APPLICATION OF THE NEW COMPONENTS TO THE PRE-MODIFICATION APPLIANCES:

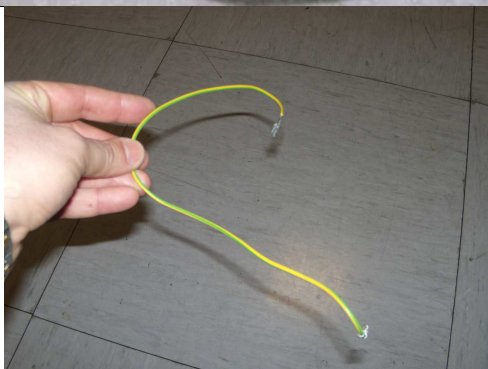
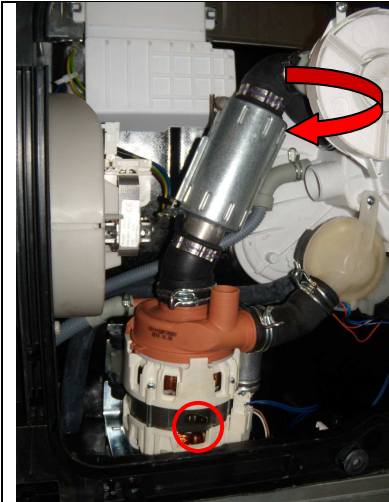
OLD WASHING MOTOR

NEW MOTOR KIT P/N KIT-MOTO (690072402).
The kit includes :a new motor+pressure switch + ground wire

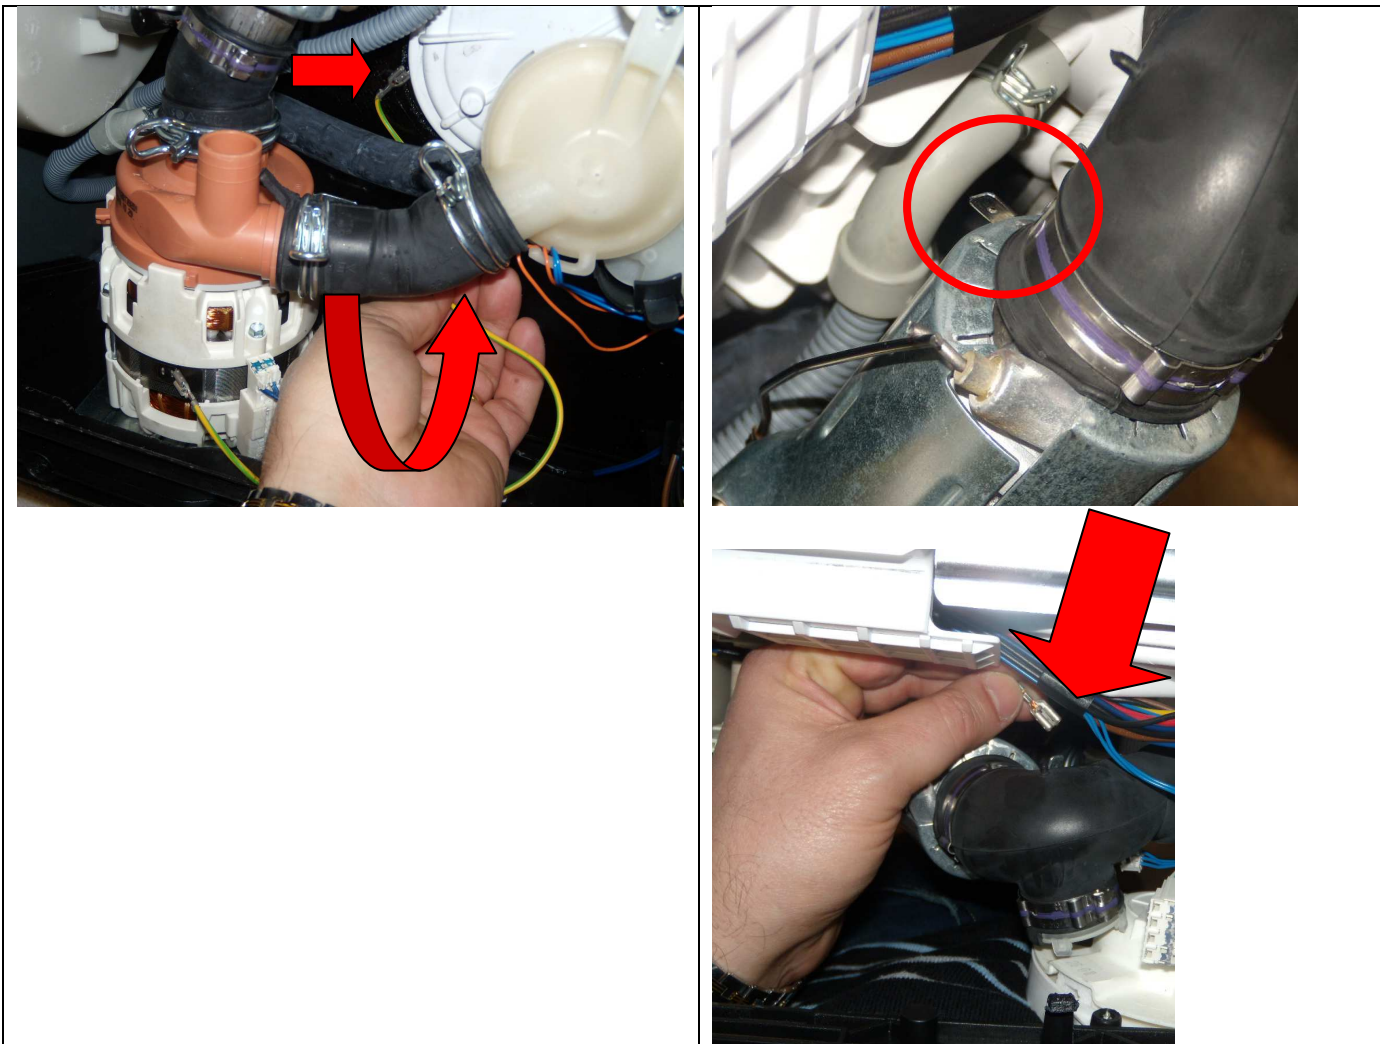
1- Replace the dishwasher's washing pump with the one included in the kit.

2- replace the existing pressure switch with the one included in the kit.

3- Connect one end of the ground cable provided to the pump ground connector and the other to the heating element ground connector

Caution !!!!! the cable must be passed through the ducts provided and must not touch the heating element
